# TECHNICAL BULLETIN

UPS4512-2bNAS1

### Update Prior to Sale: Engine Bay Harness

XJ (X351)

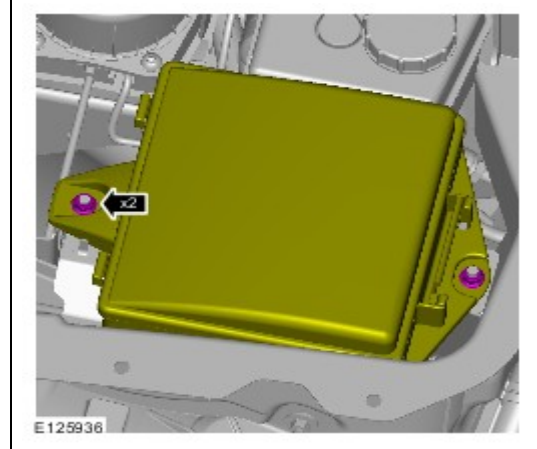
1. Remove the engine compartment fuse box cover.
  - Remove the four (4) clips.

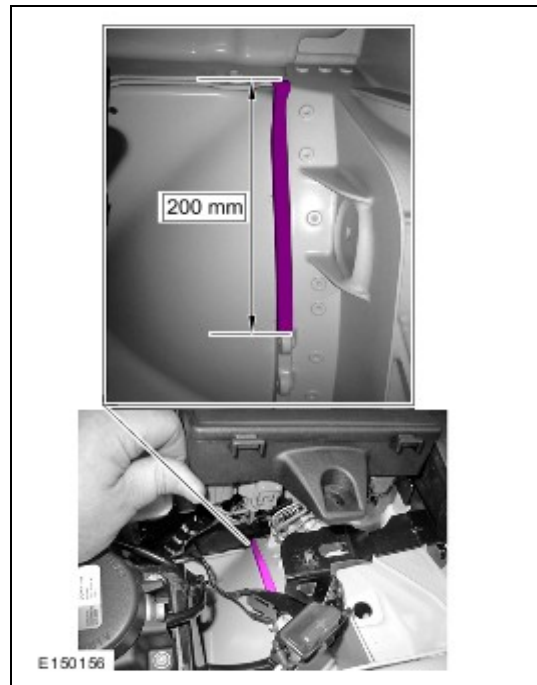
3. **⚠ CAUTION: Make sure excessive force is not applied when repositioning the fuse box.**

**⚠ CAUTION: Make sure that all sharp edges and corners are covered by the tape.**

**△ NOTE: Make sure protective tape is applied to the area as shown; some vehicles may already have tape fitted but not in the correct area.**

Reposition the fuse box and apply a 200mm (8 in.) length of protective tape to the area shown.

4. Reposition the fuse box.
  - Tighten the two (2) fuse box nuts to 7Nm.
5. Install the fuse box cover.
